THE CIVIL AVIATION AUTHORITY OF THAILAND

A 41/24 25 JUL 2024

RE-DESIGNATION OF RUNWAY 01R/19L AND 01L/19R AT SUVARNABHUMI INTERNATIONAL AIRPORT (VTBS)

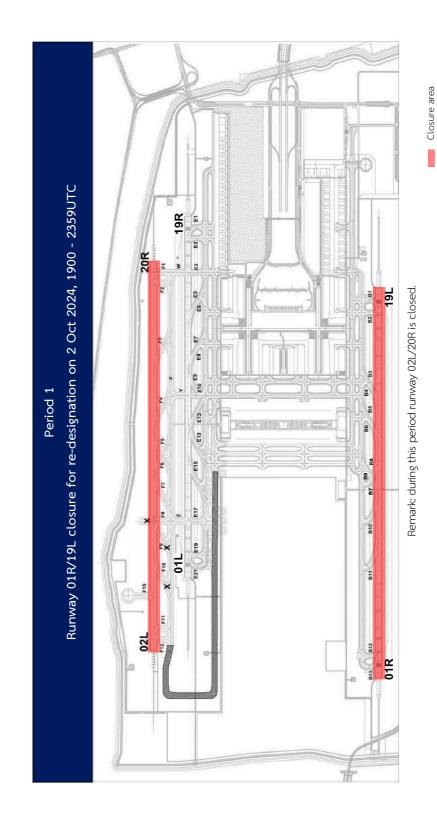
Periods	Date and Time (UTC)	Details
1	2 Oct 2024, 1900 - 2359	Runway 01R/19L will be closed for re-designation.
		Remark: during this period runway 02L/20R is closed.
		(refer to attachment 1)
2	3 Oct 2024, 0000 - 0959	- Runway 02R/20L will be partially closed for completion of final re-designation works and not be available for departing or arriving aircraft.

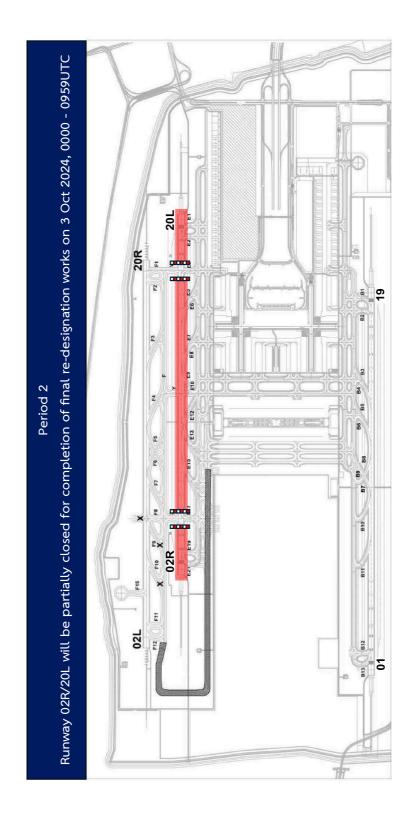
- The closed areas will be marked with barricades and closure visual aids.
		(refer to attachment 2)
		- The specific taxi route for departing aircraft are as follows
		Runway 20R: The aircraft will be instructed to taxi via E3, cross runway 20L then W and F1.
		Runway 02L: The aircraft will be instructed to taxi via E17, cross runway 02R then Z, F and F12.

- The specific taxi route for arriving aircraft are as follows
		Runway 20R: The aircraft will be instructed to taxi via F, Z cross runway 20L, then E17.
		Runway 02L: The aircraft will be instructed to taxi via F, W, cross runway 02R then E3.
3	From 3 Oct 2024, 1000	Runway re-designation complete.
		(refer to attachment 3)
